# POST OCCUPANCY EVALUATION REPORT

## GATEWAY BUILDING

FEBRUARY 2014

FINAL

# Gateway Building - C Floor Plan

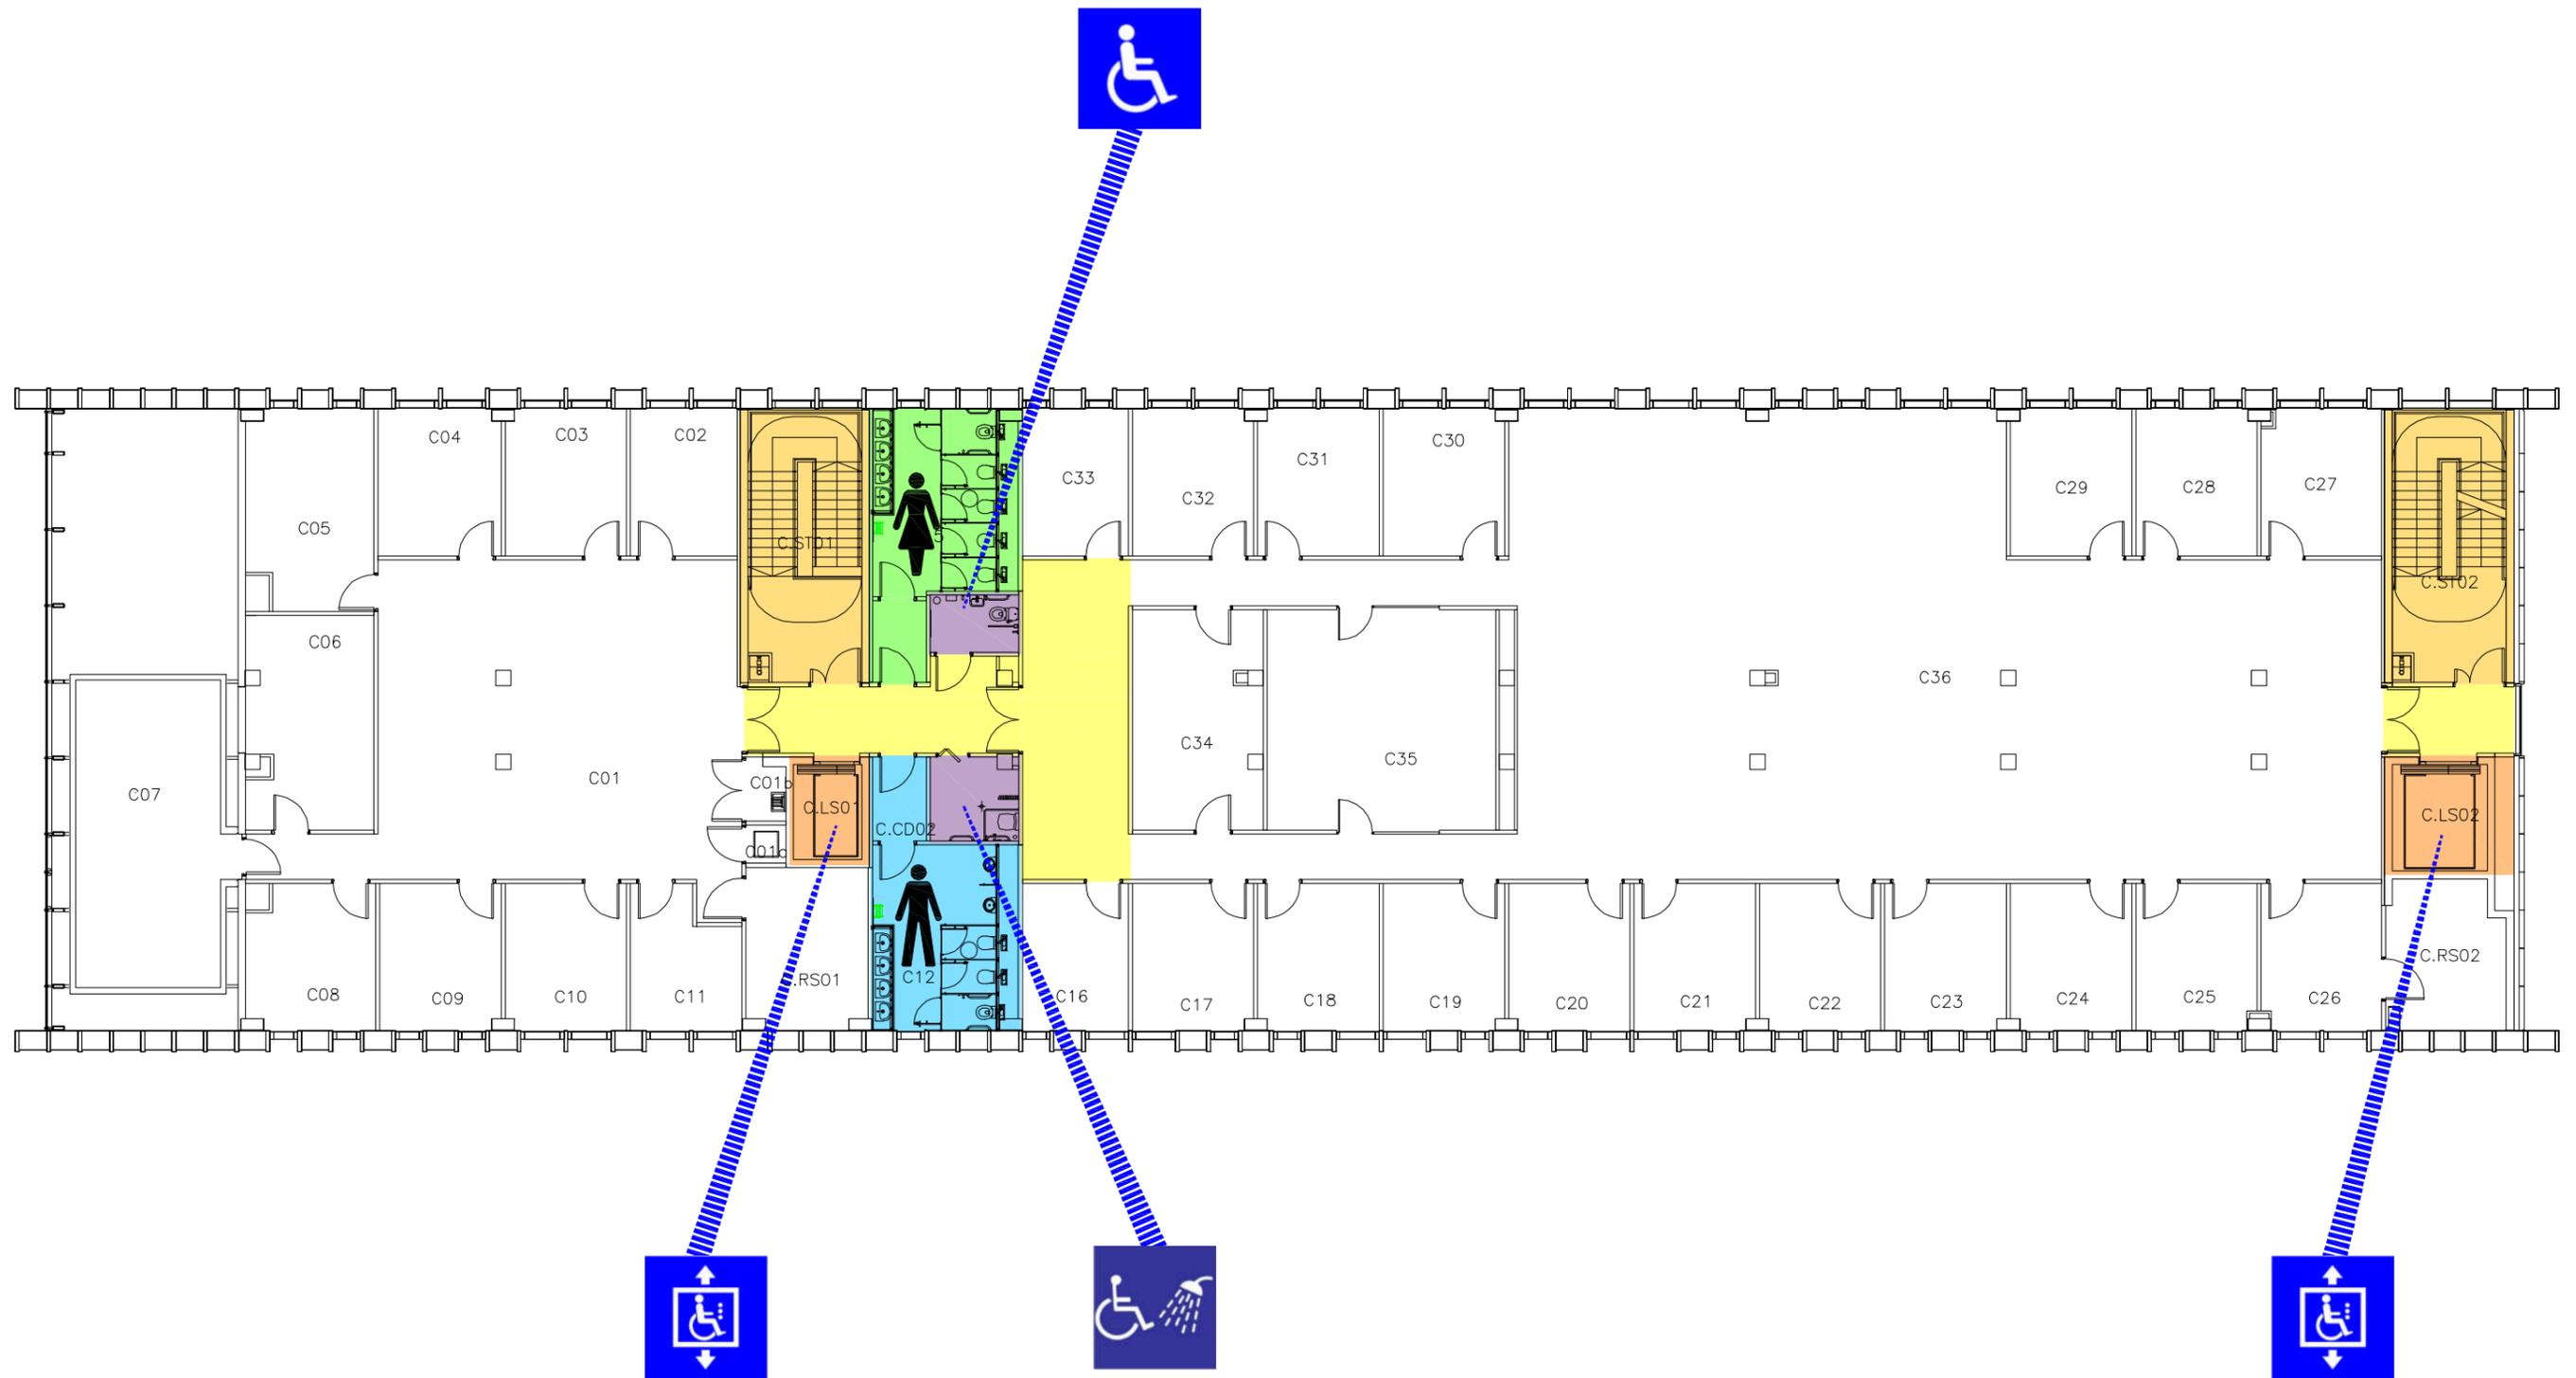
There were a number of comments from users of the open plan office space. In particular, Room C01 was singled out as an area attracting most criticism:

Disturbance by noise and distraction are obviously issues due to foot traffic to and from the perimeter offices and access to the break out area (C07). There is also no natural light to this office area. There was originally to be a rooflight over this space but it was omitted due to the extent of plant required on the roof. Removal of partitions to the office overlooking the full height atrium would help in providing some borrowed natural light.

- ii) *ii) Internal offices with no natural light that allow foot traffic through a working space result in poor working conditions. In the case of room C01, this could be improved through the introduction of borrowed light from the atrium. Removal of an office to facilitate this might be an option*
